**TOWN OF OCEAN RIDGE
PLANNING & ZONING REGULAR MEETING
AGENDA**

To:	Planning & Zoning Board Members
From:	Corey O’Gorman, Town Planner
Meeting Date:	July 21, 2026
Subject:	5920 N Ocean Blvd – Development Plan Review

PLAN REVIEW REPORT
5920 N Ocean Boulevard
05/06/2026 – 06/04/2026 – 07/14/2026

ASIR RESIDENCE
MAY 2026 TOWN PLANNER COMMENTS — COMPLIANCE RESPONSE
03 / 08

Sheet G1.0 — Impervious vs. Green Space with Area Calculations

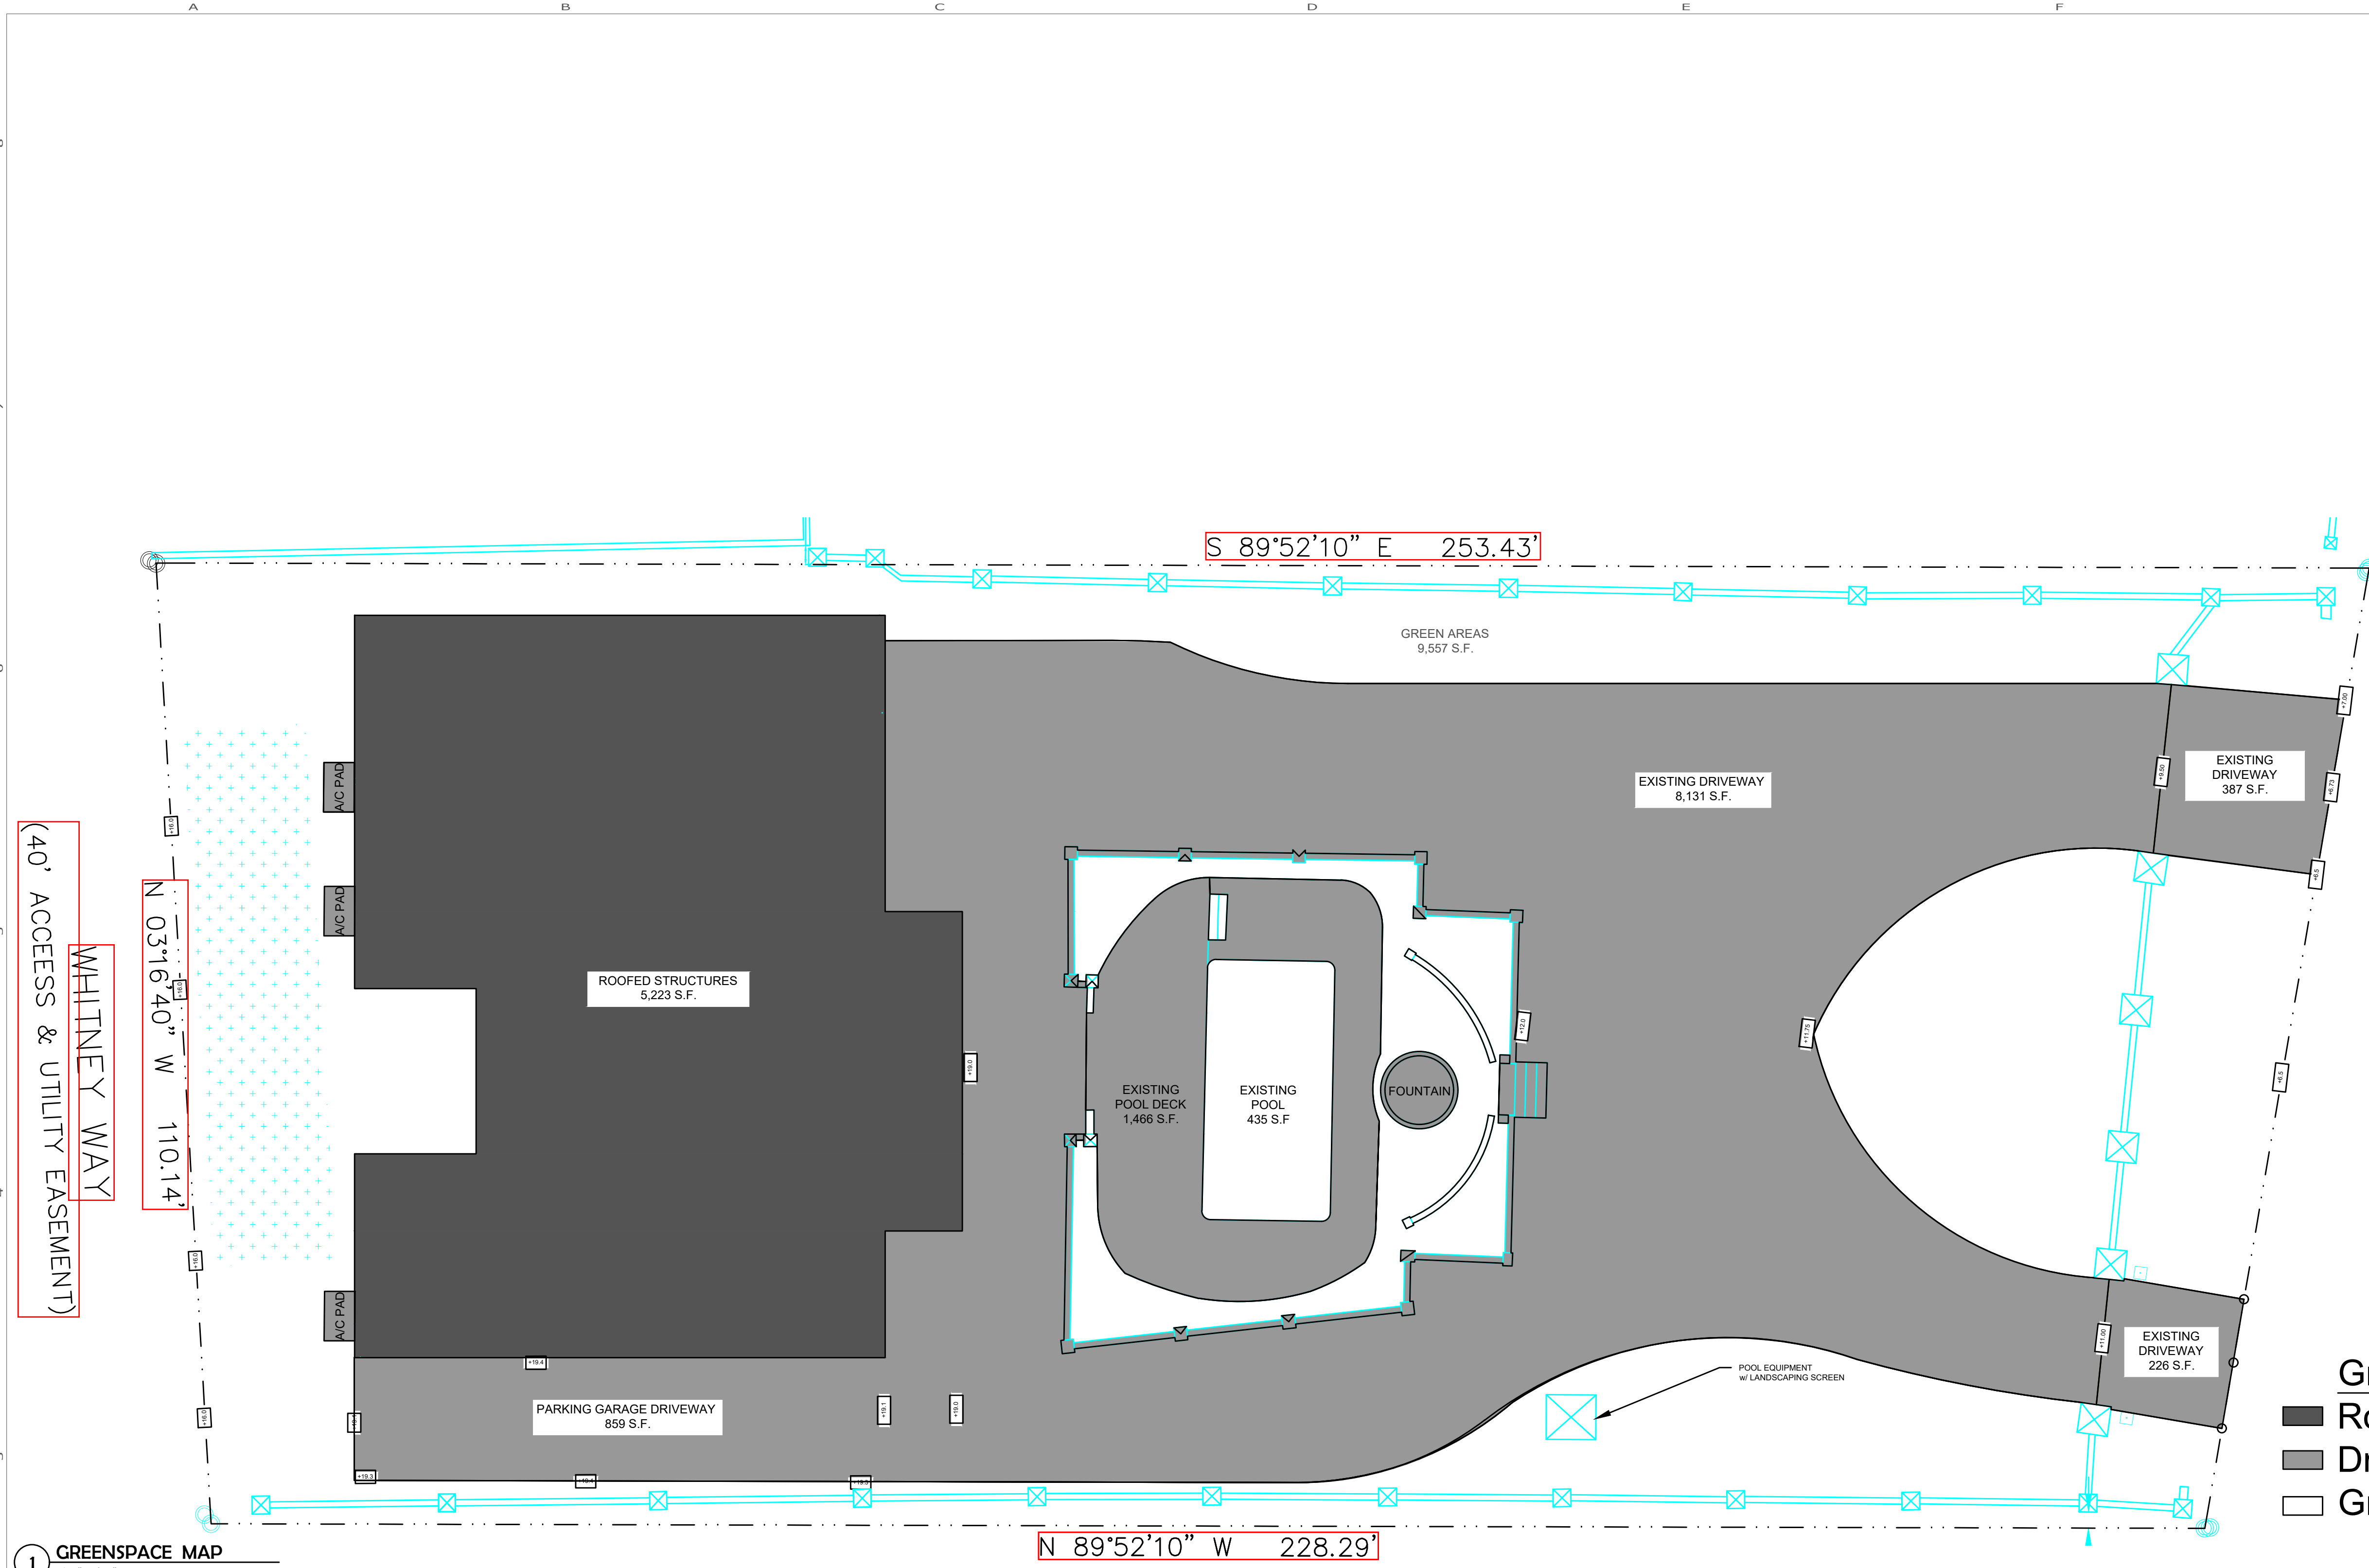
~~Comment: Please revise the plan to comply with the minimum pervious area requirement. Sheet G-1.0, Greenspace Map, shows a total green area of 9557 square feet which is 36% of the lot area and complies with this requirement. This comment is addressed.~~
